Mealstream EC501 (Series 5) CTM3 208V, 60Hz
FCC ID: PCVCTM3206015A
FCC Class II Permissible Change

Description of changes

Heater Control Circuit Proposal

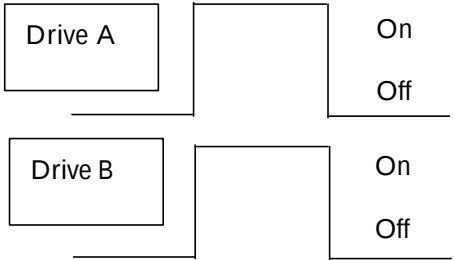
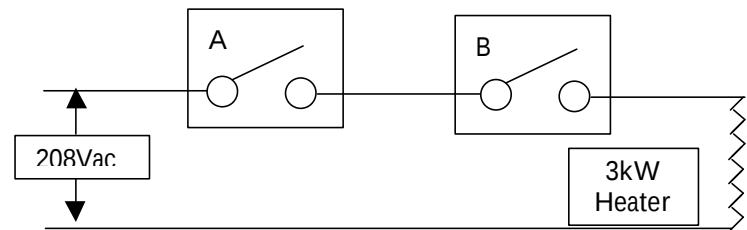
5. Inclusion of Opto-Triac (30Z1189) within the heater control circuitry.

Refer to the block diagram at the end of this document.

A Semiconductor Triac device has been added in the heater control circuitry. Before the modification, the convection heater element was controlled by two series connected relay contacts. The two relay contacts were operated sequentially but could be switched whilst current is flowing.

The modified circuit uses a Triac, which performs the function of zero crossing detection. This allows sequential switching of the relay contacts such that there is minimum current flowing when the relay switch contacts change over.

The control logic to drive the Triac is isolated from the mains switching voltages by means of an opto-isolated triac linked to the switching triac.

The reduction of relay switching current will increase electro-mechanical switch contact life and therefore improve the reliability of the product.
